2.2.1 Master Responses

Master Response No. 1, Geological Conditions Underlying the LBNL Hill Site

2.0 Comments on the Draft EIR and Responses to Comments

Bedrock Geologic Map of LBNL

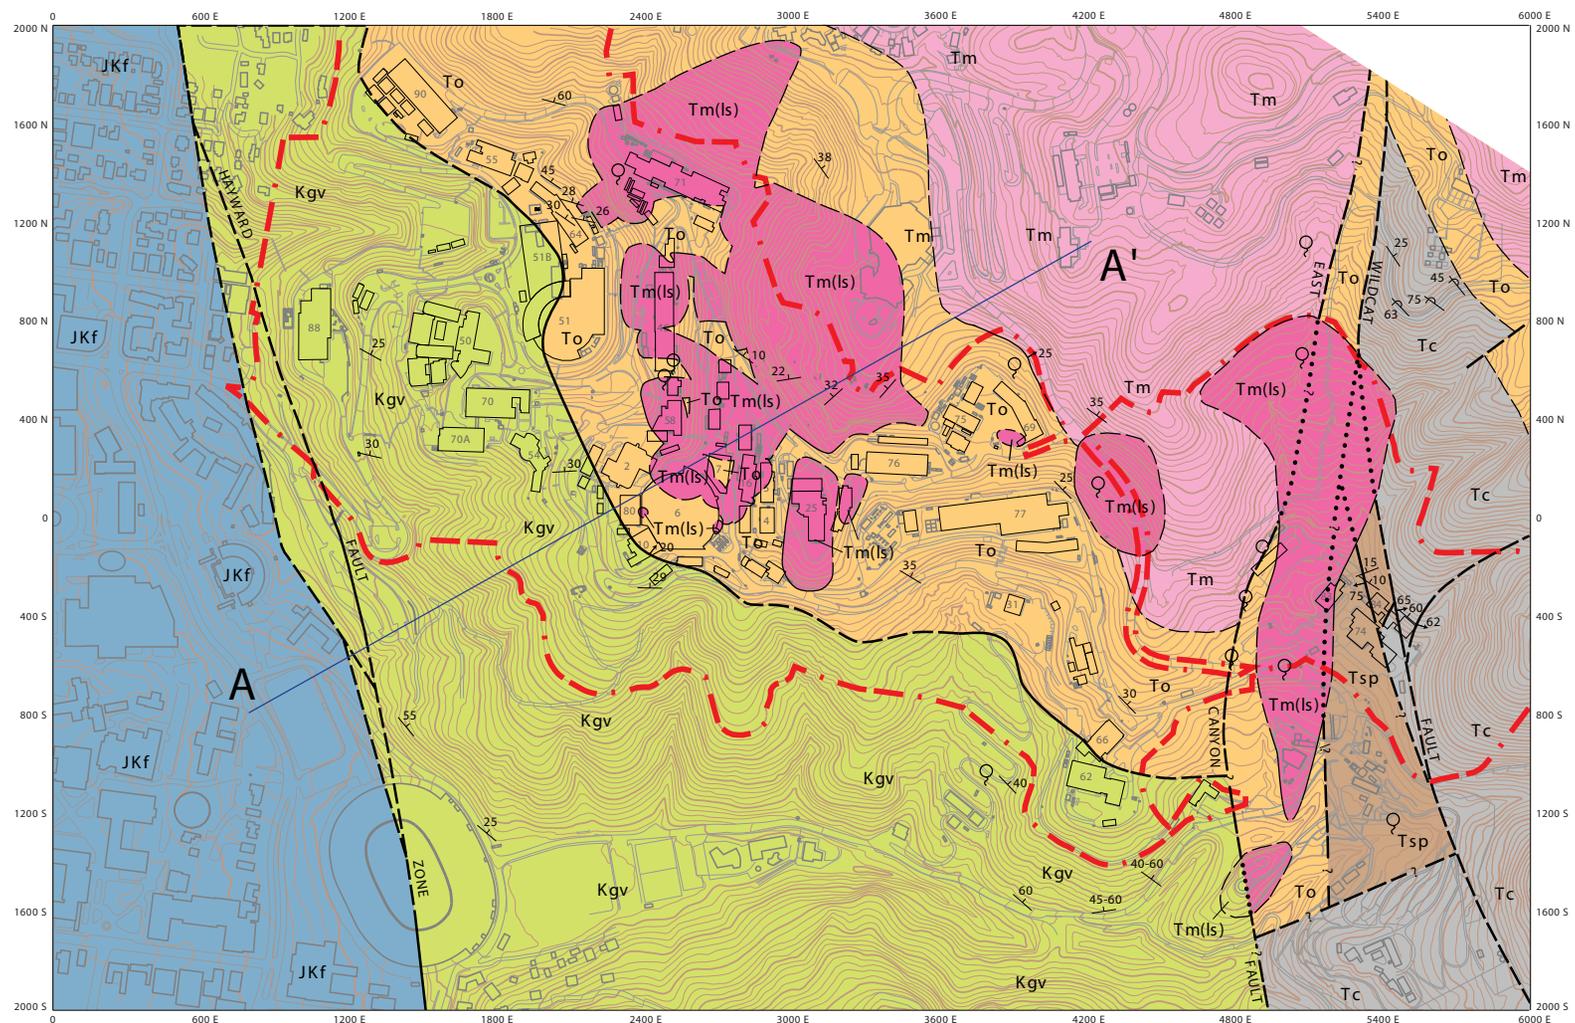
Many public comments on the SERC Draft EIR state or suggest that no more buildings should be constructed at Lawrence Berkeley National Laboratory (LBNL) due to unstable geological conditions of the main hill site. Comments largely reiterate or mirror the hypotheses put forward by University of California Berkeley (UCB) Professor Emeritus Garniss Curtis in an article published in the Berkeley Daily Planet in the autumn of 2008. This master response has been developed to address comments from the public regarding the geology of the main hill site and to correct factual errors and misrepresentations presented in those public comments.

In his 2008 article, Professor Emeritus Curtis argued that LBNL is underlain by two geologic structures of concern: (1) a volcanic caldera containing material with low strength, and (2) west-dipping Cretaceous strata sub-parallel to the slope above Foothill student housing. He alleged that both these features make the site particularly unstable.

Figure 1 shows the most recent and comprehensive bedrock geology map of the entire LBNL site, which was prepared by Parsons Engineering Science, Inc. (PES) and UC LBNL. This mapping data was drawn from hundreds of borings as well as from trenches, outcrops, construction excavations, and road cuts (PES and UC LBNL 2000). This map indicates that, contrary to the assertions by some commenters, volcanic rocks do not underlie most of the LBNL site, but rather occur in various isolated to semi-isolated masses. Calculations from this map indicate that 46 acres of the 202-acre site, or 23 percent of the LBNL property, is underlain by volcanic rock, sedimentary rock intercalated with volcanic rock, and sedimentary rock including volcanoclastics. The majority of these 43 acres are currently not developed, and the LBNL 2006 Long Range Development Plan (LRDP) and EIR do not anticipate further development in these areas.

FIGURE 3.0-7

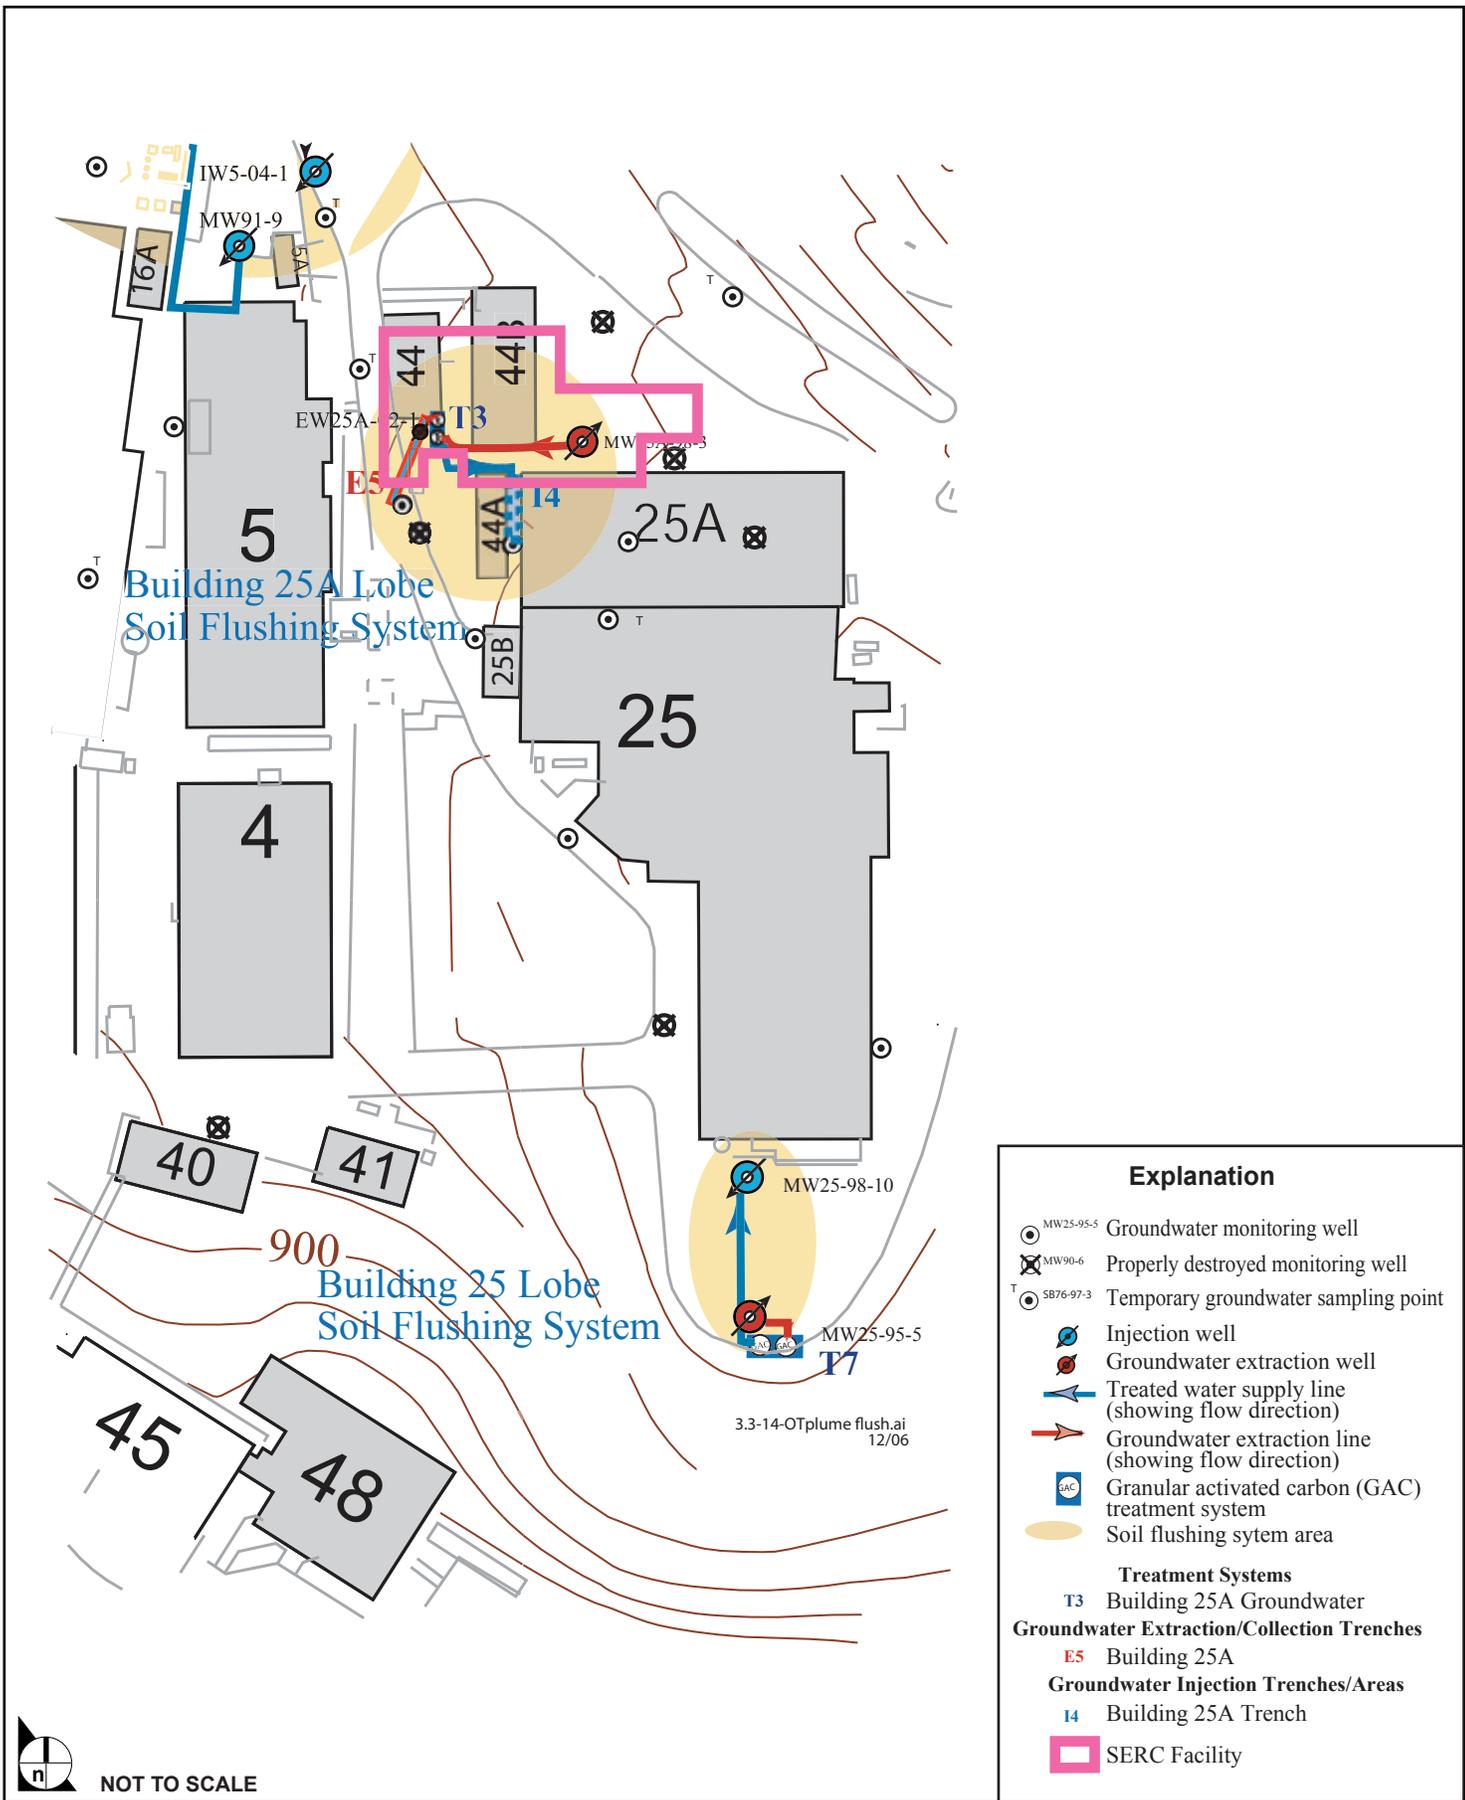
BR-13	<p>In addition, I have questions about the symbols on figure 3.0-7.</p> <p style="text-align: center;">  </p> <p>Symbols    are not included in the Explanation box. Are these wells or bore-holes?</p>	<p>As published in the April 2007 RCRA Corrective Measures Implementation Report prepared for the LBNL hill site, the first symbol represents a properly destroyed monitoring well, the second symbol represents a groundwater monitoring well, and the third symbol represents a temporary groundwater sampling point. Figure 3.0-7, Soil Flushing and Groundwater Migration Control System, has been revised to include these symbols in the legend, as shown at the end of this table.</p>
